ARCHITECT'S SUPPLEMENTAL INSTRUCTION NO. 5

DATE: February 19, 2024 **PROJECT NO:** 230117

RE: Streets of West Pryor – Lot 5 Core & Shell

SHEET NUMBER
S-102

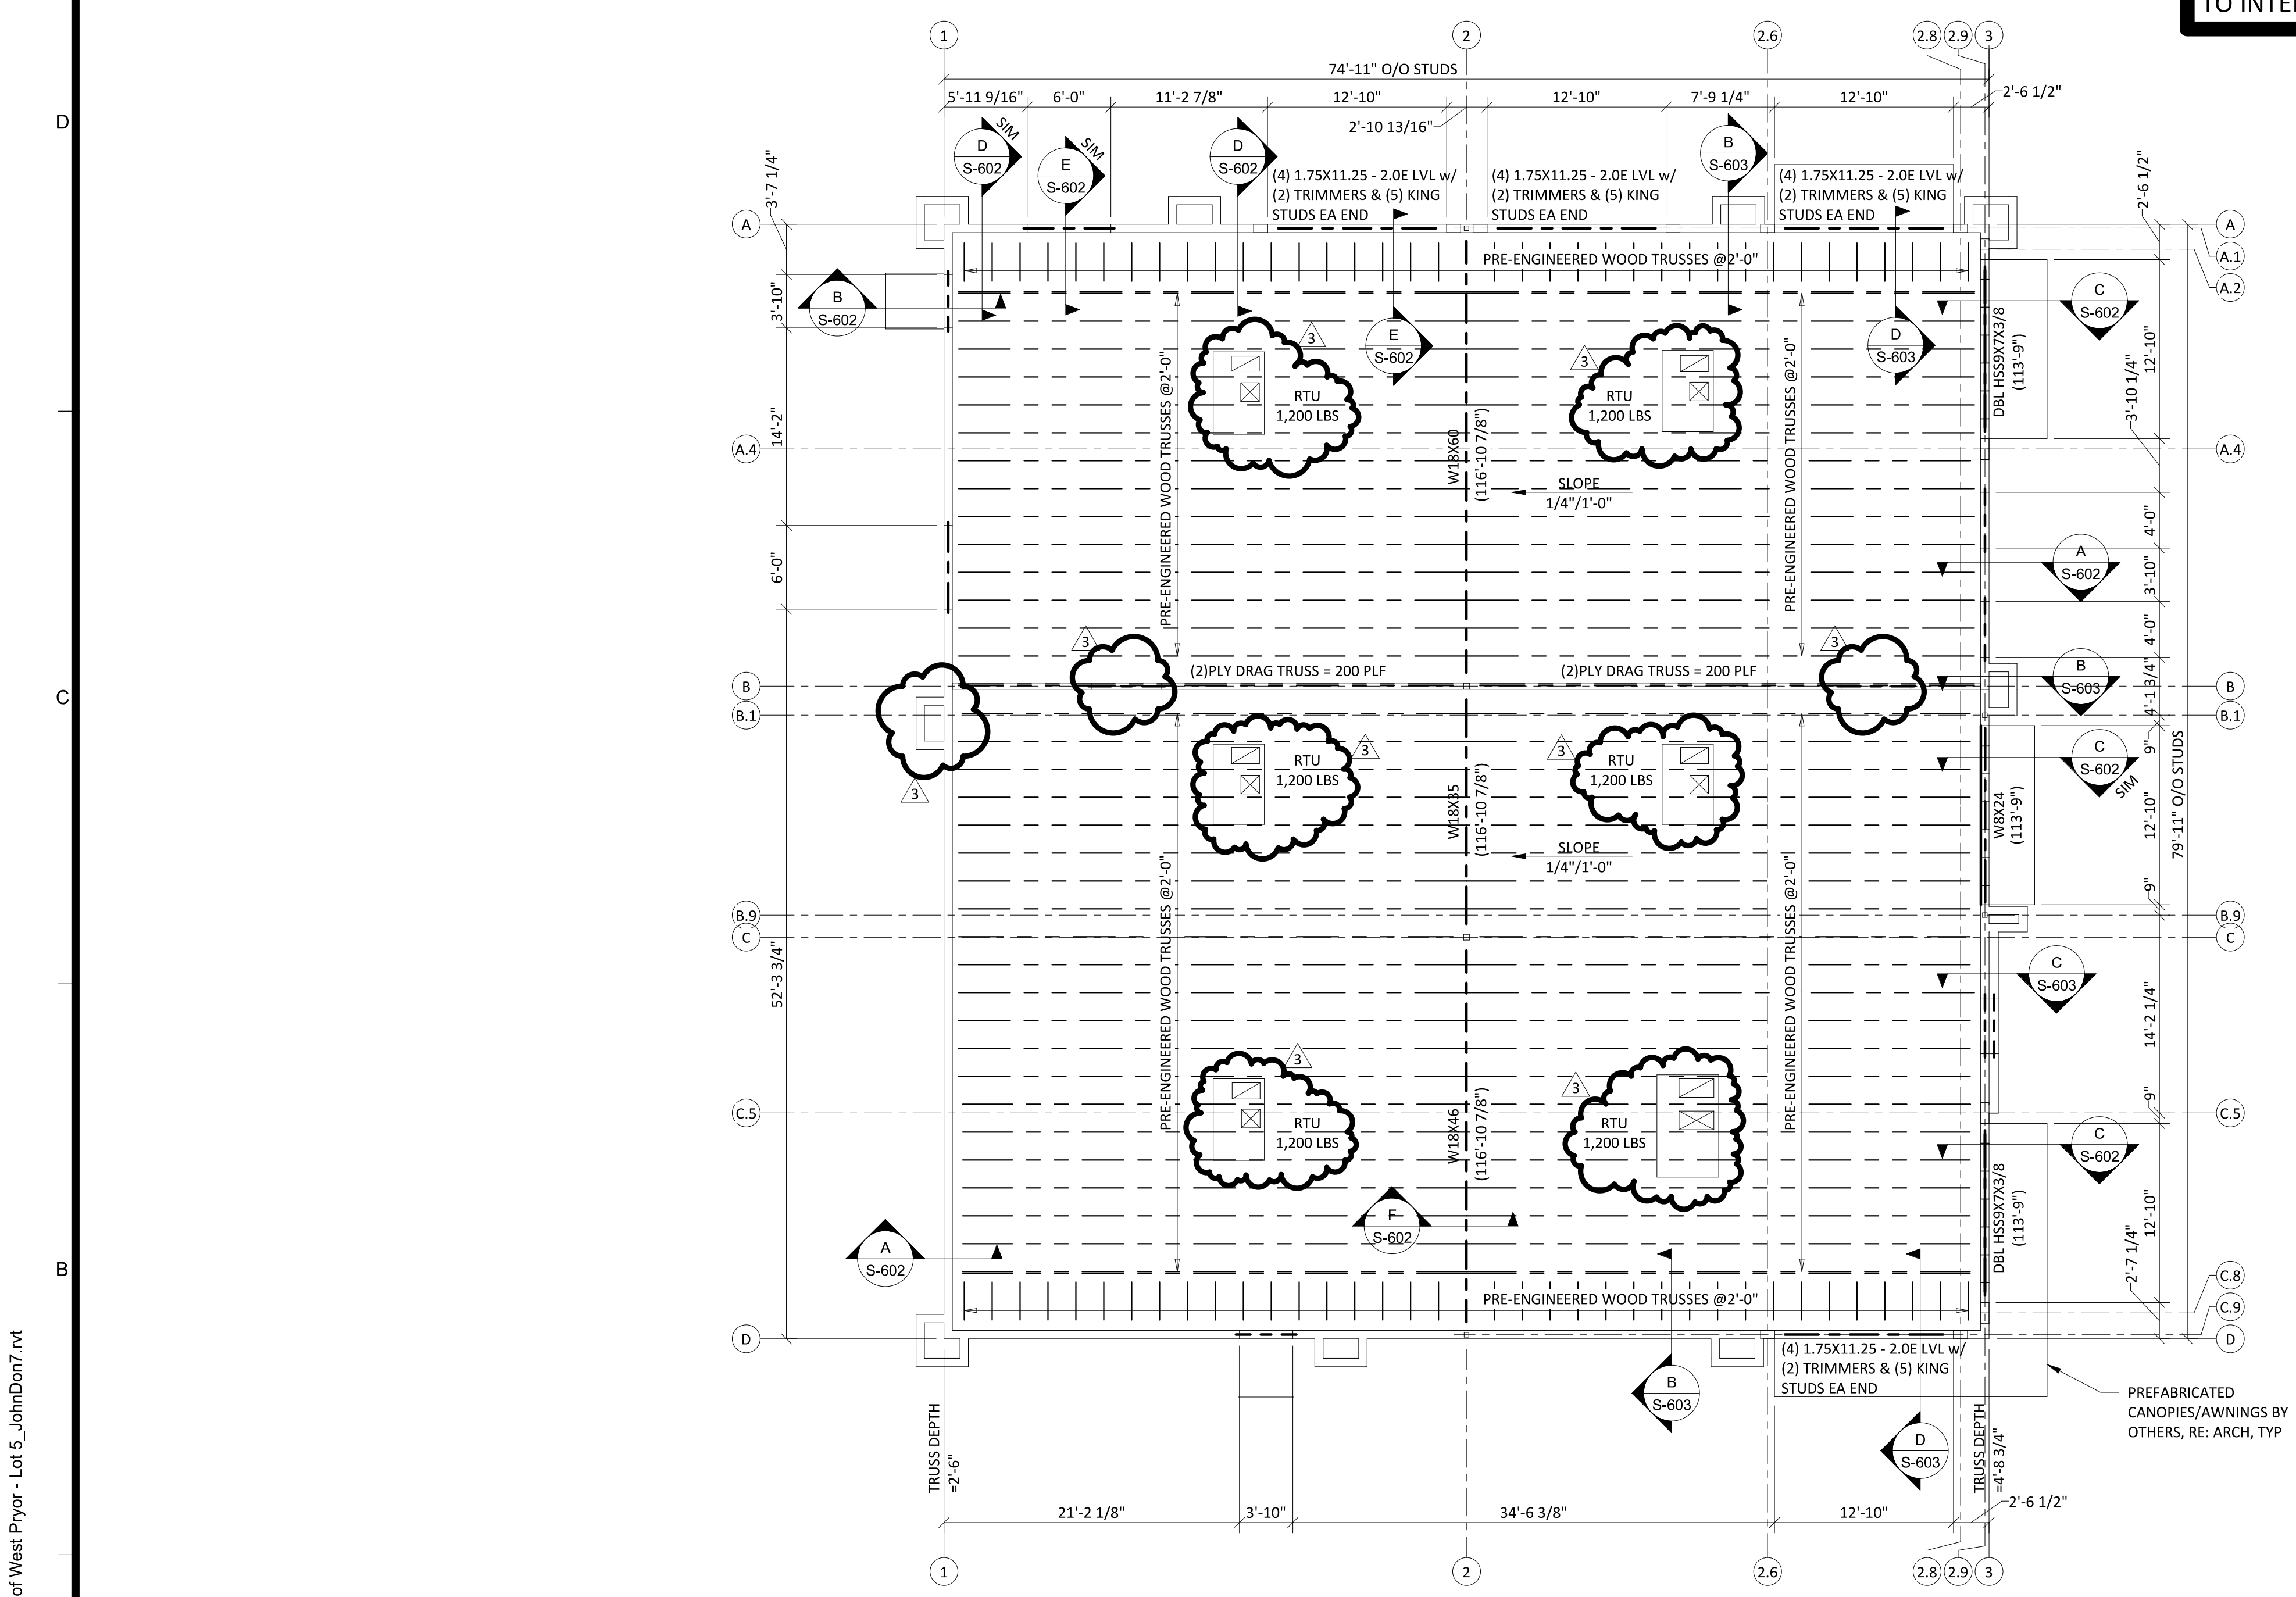
S-1 Sheet S-102 - Updated location of future pass-through openings on Suite C's South demising wall.

SHEET TITLE
PLUMBING FLOOR PLAN

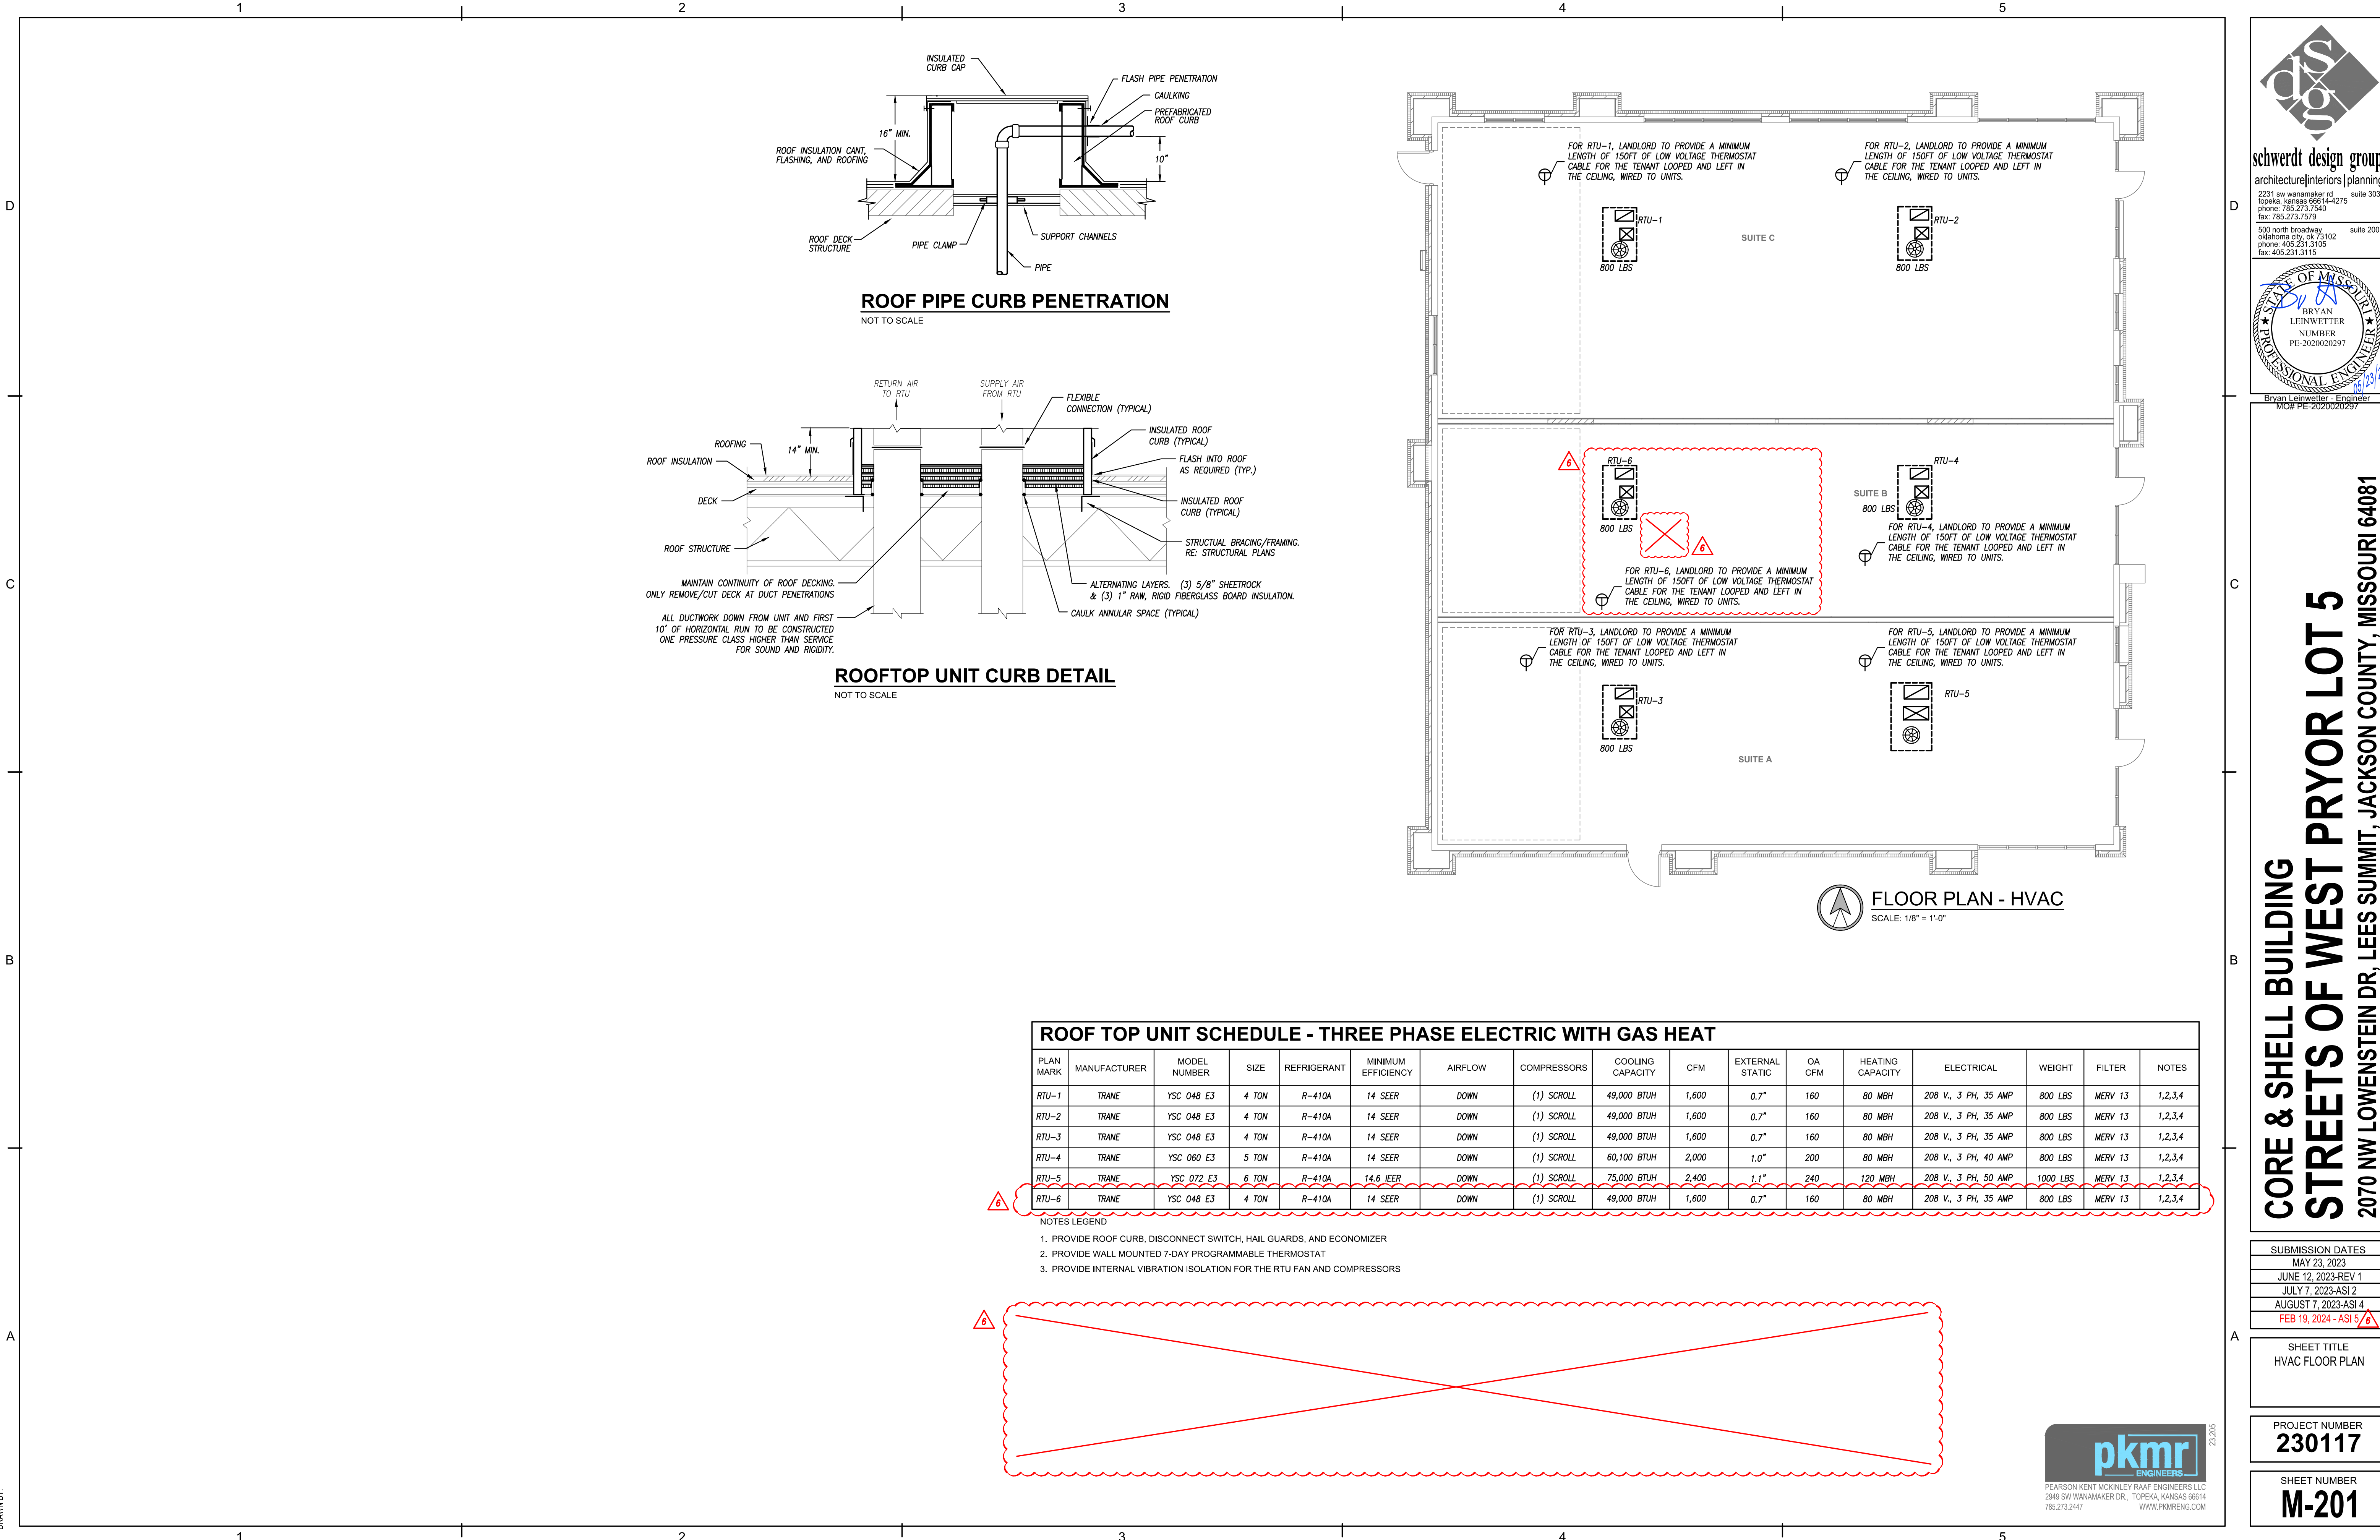
- MEP-1 Sheet M-101 – Restroom removed; RTU added to service enlarged Tenant Suite B space.
 - MEP-1.A Water heater and Plumbing Fixture schedules removed.
